SUNDRY NOTICES AND REPORTS ON WELLS MAR 18 2009

| 3a Address 200 LORAIN, STE. 800 MIDLAND, TX 79701 | 3b Phone No (include area code) 432-620-6740 | 8 Well Name and No EUNICE MONUMENT 911 SOUTH UNIT B |
| 4 Location of Well (Footage, Sec., T., R., M., or Survey Description) 1980 Feet from the South line and 1980 Feet from the East line; Unit Letter J, Section 24, T-20-S, R-36-E, NMPM, Lea County, New Mexico | | 9 API Well No. 30-025-04311 |

WELL DATA SHEET

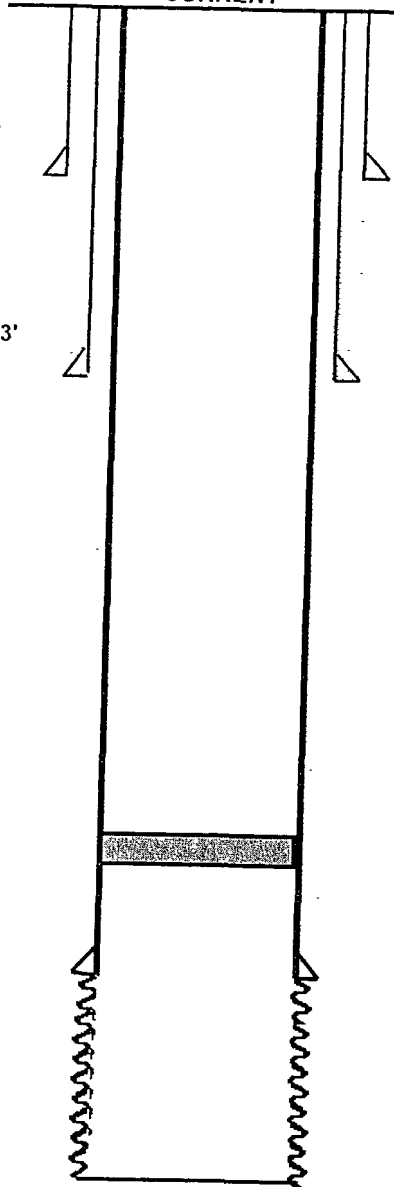
* 4) Perf @ 1500' squeeze w/adequate amt to fill from 1500'-1140' in/out of 7" csg. woc tag.

* 5) Perf @ 600' squeeze w/adequate amt to fill from 600'-surf. in/out of 7" & 9 5/8" csg.

**SEE ATTACHED FOR
CONDITIONS OF APPROVAL**
